TO: T10 Membership
FROM: Paul A. Suhler, Seagate Removable Storage Solutions, LLC
DATE: 19 March 2003
SUBJECT: T10/03-140r0, ADI Figures

ADC Figure 2 revised:

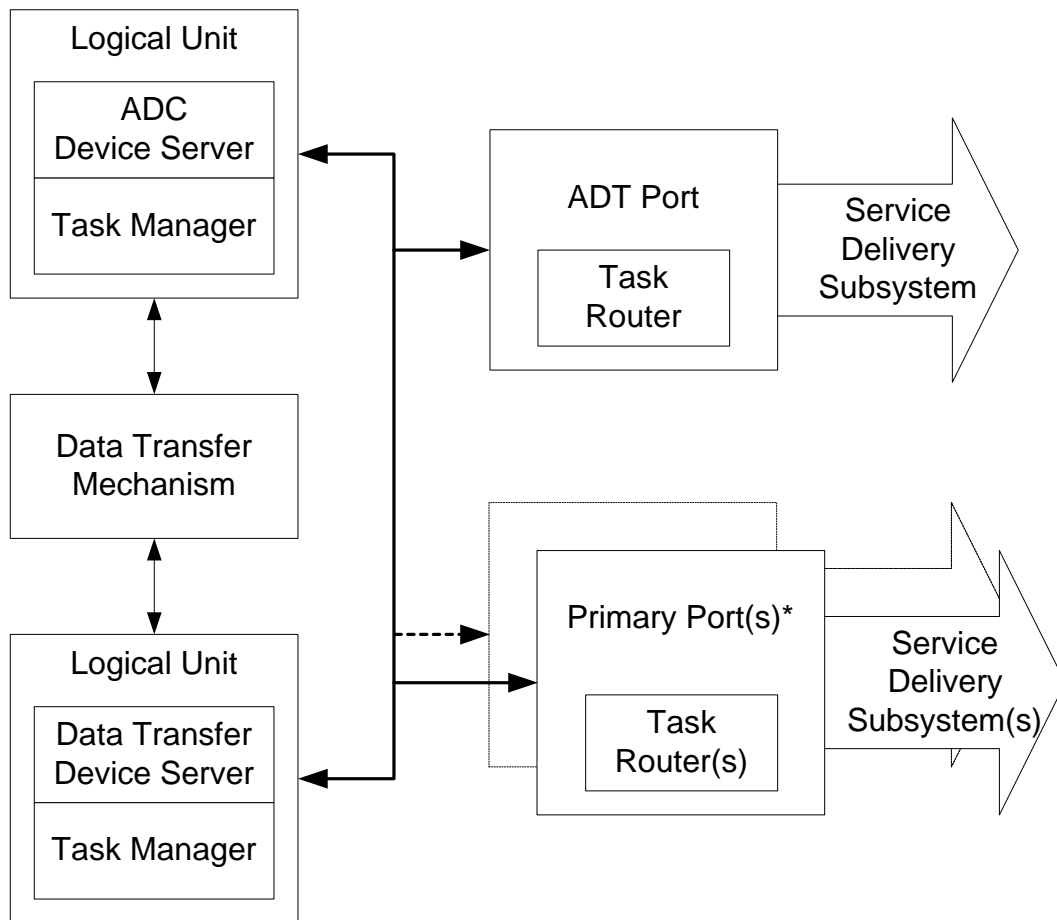
* Primary transport protocol ports are not necessarily SCSI ports.

Figure x – Automation and data transfer device relationship for bridging

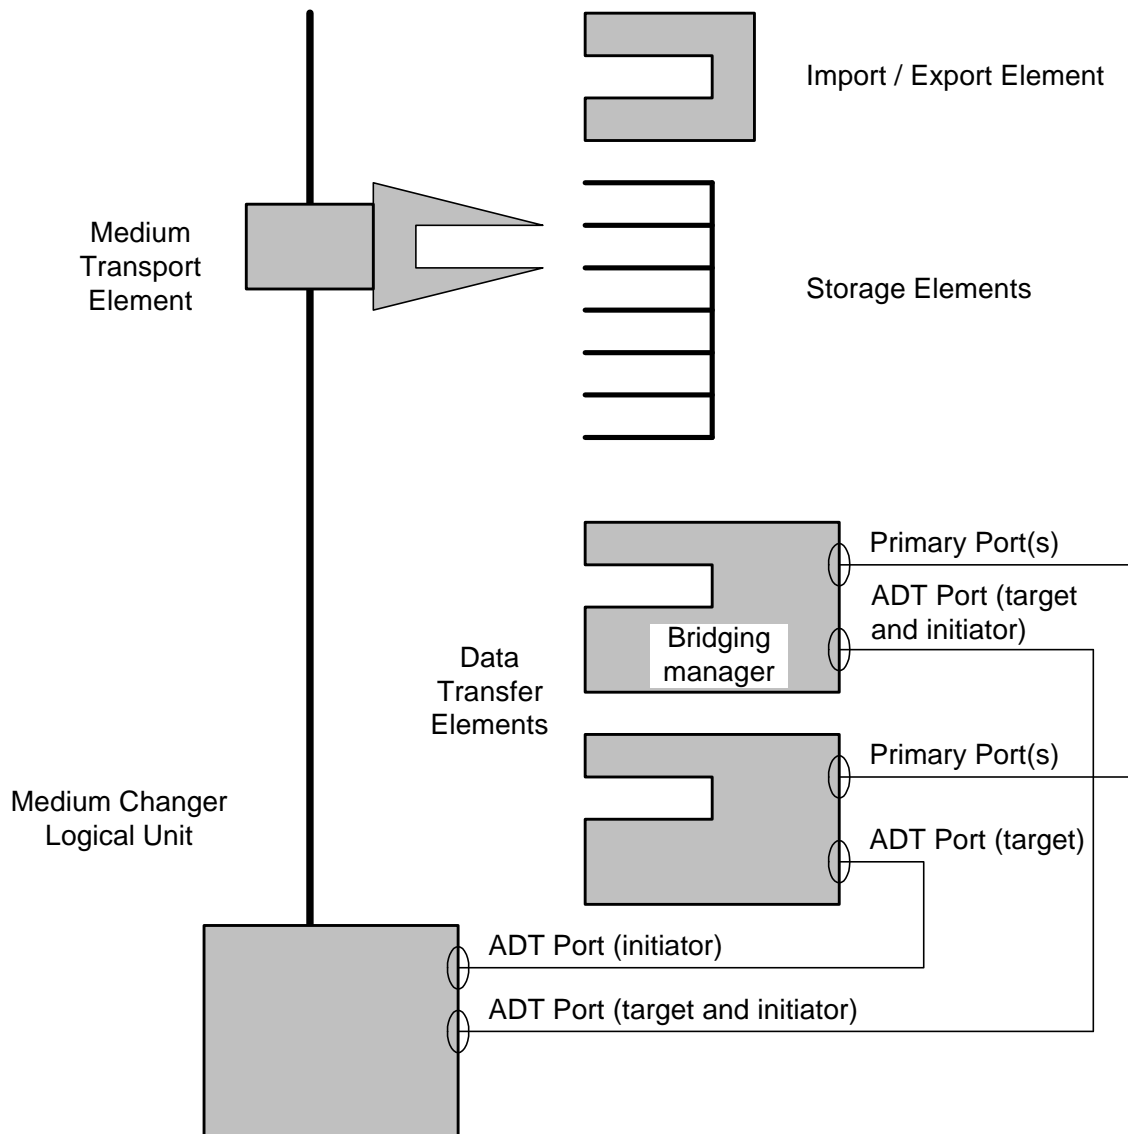
Figure x shows a system in which the medium changer has only ADT ports and one of the data transfer devices is performing bridging. The upper data transfer device contains an active bridging manager and its ADT port is operating both in initiator mode (to issue commands to the medium changer) and in target mode (to receive commands initiated by the medium changer). The corresponding ADT port on the medium changer also operates in both modes.

The lower data transfer device is not performing bridging and its ADT port only operates in target mode. The corresponding ADT port on the medium changer only operates in initiator mode.

Editor's Note: Should this figure also be included in ADT?
